Government of India - Ministry of Railways
Research, Designs & Standards
Organization, LUCKNOW - 226011

MODIFICATION SHEET NO.RDSO/2009/EL/MS/ 0382 (REV.0), dated: 08.09.2009

Modification in QVCD interlocks connection in Q51 circuit

Annexure-II

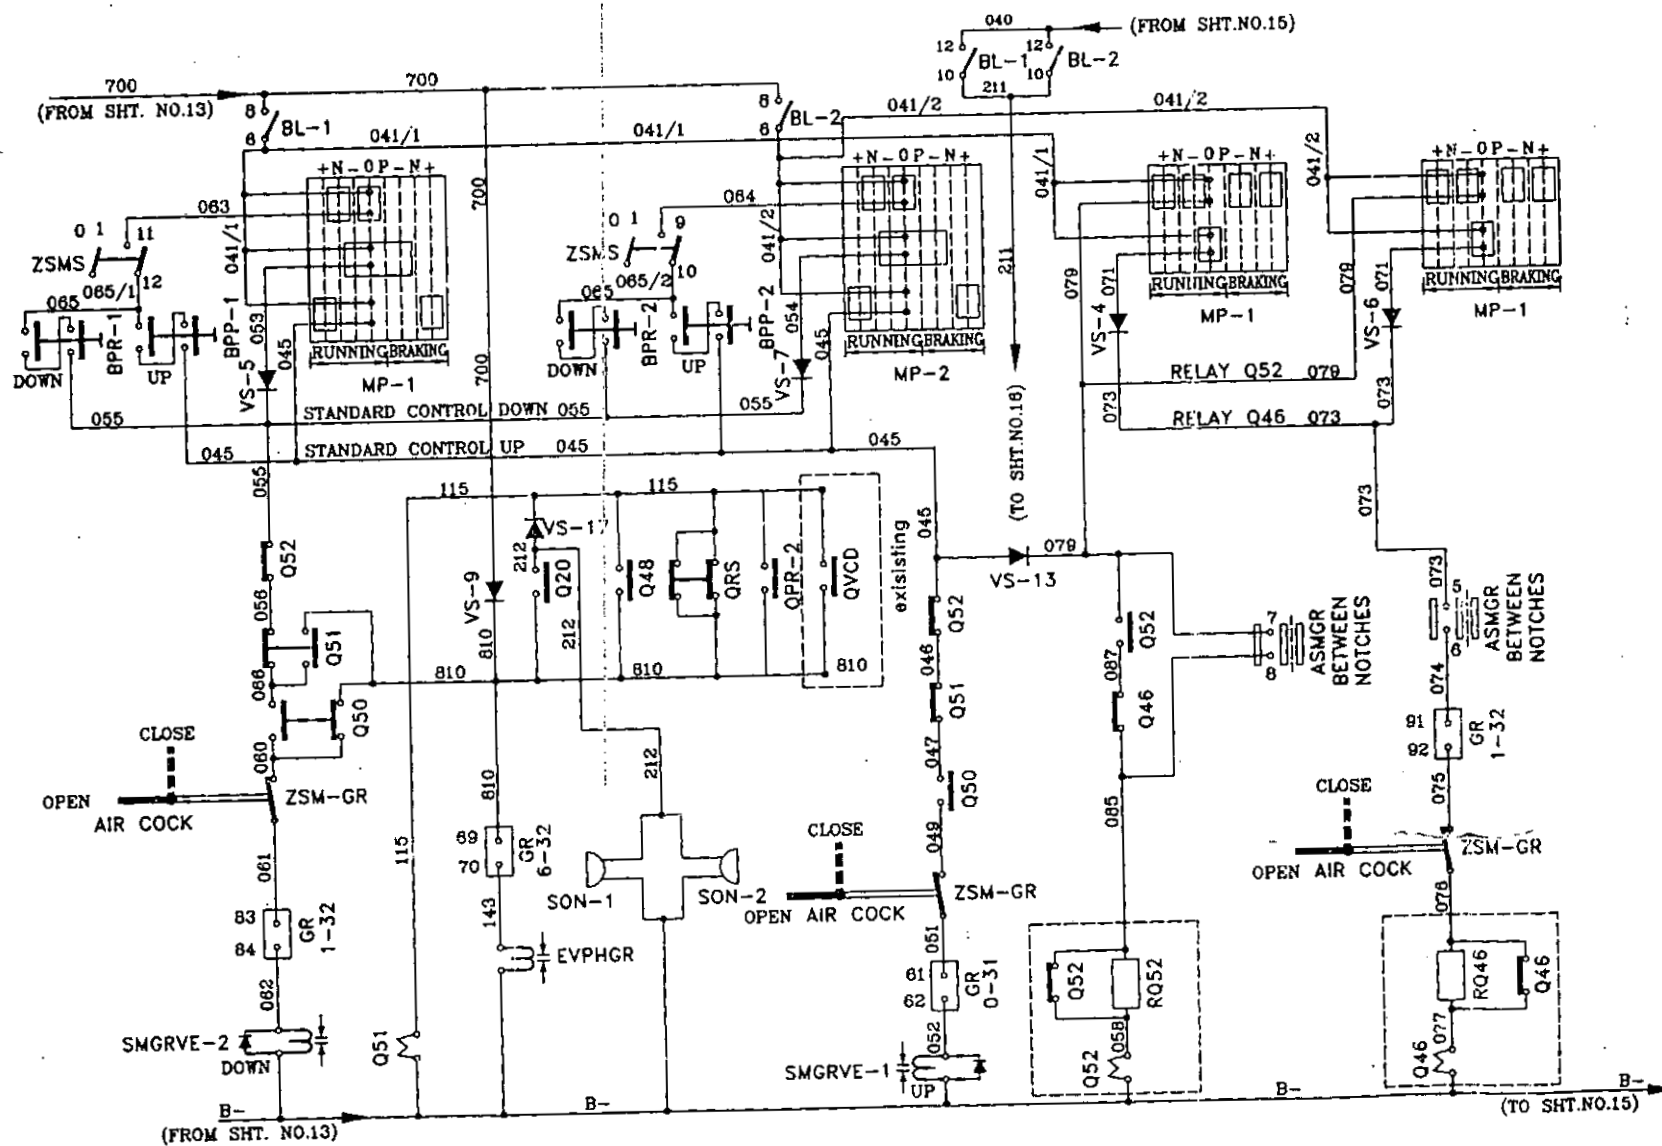
In the locomotives where Vigilance Control Devices are provided, a PC8 relay called QVCD is also provided for emergency braking through IP Valve and causing regression through Q51 relay in the event of VCD going into penalty brake cycle in case the driver is inattentive. Due to problems of wheel slipping, normally Q51 is wedged by the drivers, which can cause problematic situation of emergency brake application but regression not taking place due to use of QVCD interlock in Q51 circuit.

To overcome situation of emergency brake application but regression not taking place due to use of QVCD interlock in Q51 circuit.

N/O interlock of QVCD relay which is presently connected between wire no. 810 & 115 should be removed and connected between 810 & 055. The existing and modified circuit is attached.
